IOWA COLONY PLANNING AND ZONING COMMISSION MINUTES OF MAY 11, 2021

Re: Meridiana General Development Plan Letter of Recommendation to Approve City of Iowa Colony Project No. SPP 210510-0643 Adico, LLC Project No. 16007-2-202

SIERRA VISTA WEST AMENDMENT #1 PLAN OF DEVELOPMENT

Date:May 26, 2021To:Planning Commission MembersFrom:Dinh V. Ho, P.E.RE:City of Iowa Colony Planning & Zoning Commission Meeting, June 2021CC:Mayor Michael Byrum-Bratsen, Ron Cox, Kayleen Rosser

Figure 2 General Development Plan

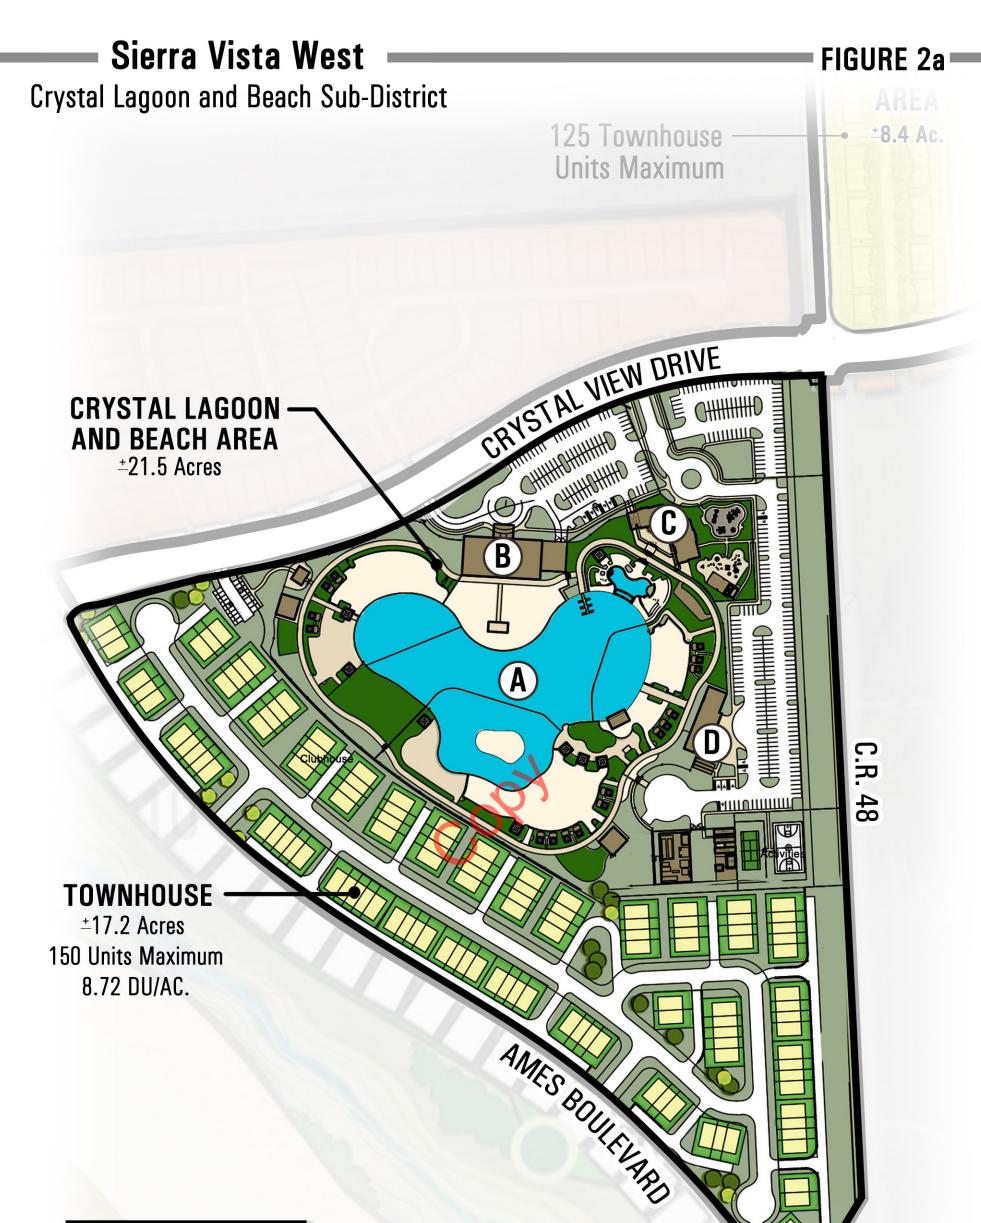
The proposed "Swing" use should be changed to a specific land use. Swing use should not be allowed as it creates future conflict and confusion. If the developer desires to change a land use, he should submit a Plan of Development amendment for approval.

Street Cross Section for Spine Road (Divided) with Shared Use Trail

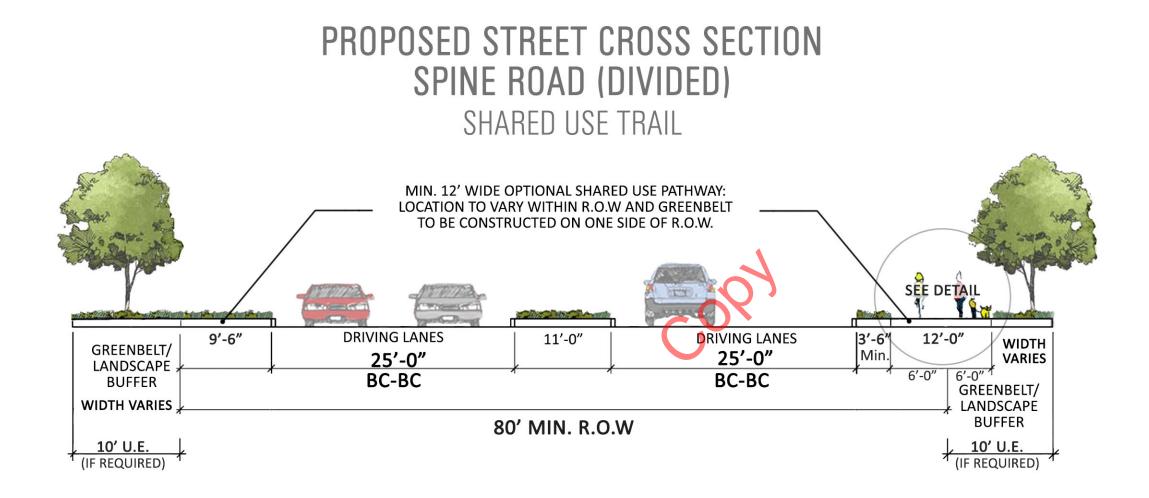
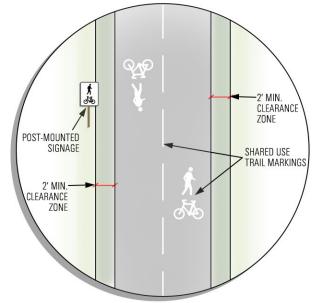
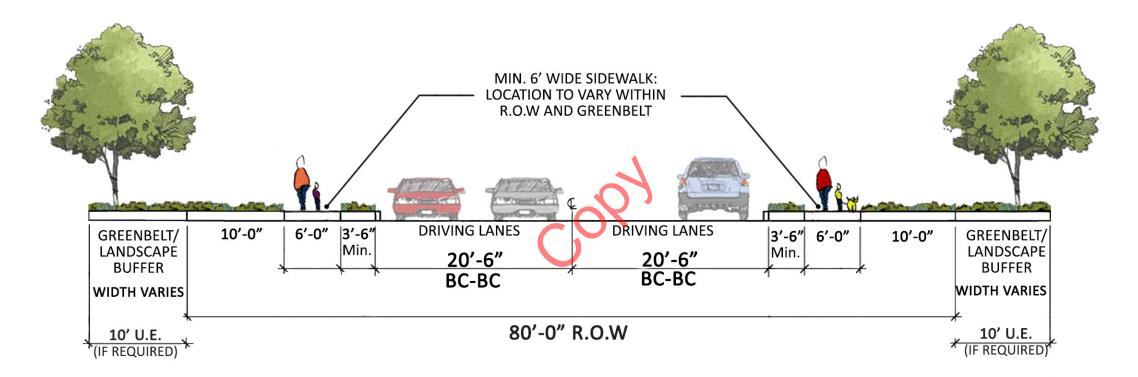
A note should be added that indicates pedestrian transition to sidewalks on both sides of the street will be made at a mid-block crossing.

Street Cross Section for Spine Road (Undivided) with Shared Use Trail

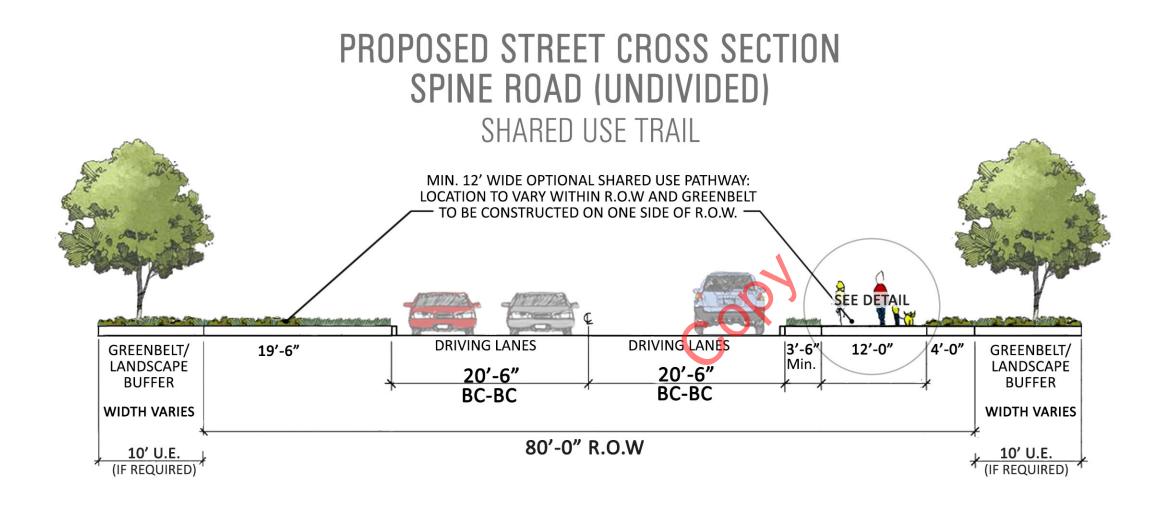
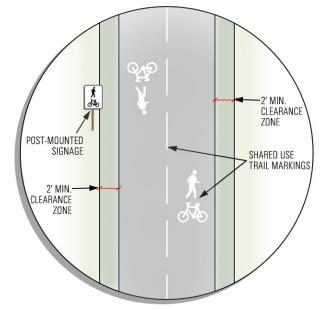
A note should be added that indicates pedestrian transition to sidewalks on both sides of the street will be made at a mid-block crossing.
